MECKLENBURG COUNTY
DEPARTMENT OF ENVIRONMENTAL HEALTH

APPLICATION FOR SOIL INVESTIGATION

SITE EVALUATION

RE: Property located at 833 Woodland Lane

**See Diagram on Back (includes: soil areas, property lines, roads, streams, gullies, wet areas, fill areas, wells, water bodies, slopes)

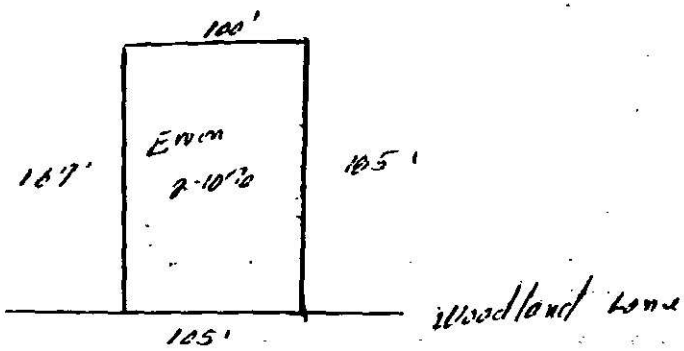
FACTORS	AREA 1	AREA 2	AREA 3	AREA 4
1. SLOPE (%)	S PS 2-10% U	S PS U	S PS U	S PS U
2. SOIL TEXTURE (12-36 inches) Sandy, Loamy, Clayey (Note 2-1 Clay)	S PS 2-1 clay U	S PS U	S PS U	S PS U
3. SOIL STRUCTURE (12-36 inches)	S PS Blocky U	S PS U	S PS U	S PS U
4. SOIL DEPTH (inches)	S 30-36" PS U	S PS U	S PS U	S PS U
5. RESTRICTIVE HORIZONS (Inches) (Impervious strata, Rock)	S +36" PS U	S PS U	S PS U	S PS U
6. SOIL DRAINAGE/GROUNDWATER (external and internal)	S +36" PS To Ground water U	S PS U	S PS U	S PS U
7. OTHER (Specify)	S PS U	S PS U	S PS U	S PS U

8. SOIL GROUP IC B

9. SITE CLASSIFICATION Unsuitable

10. SOIL SERIES Iredell
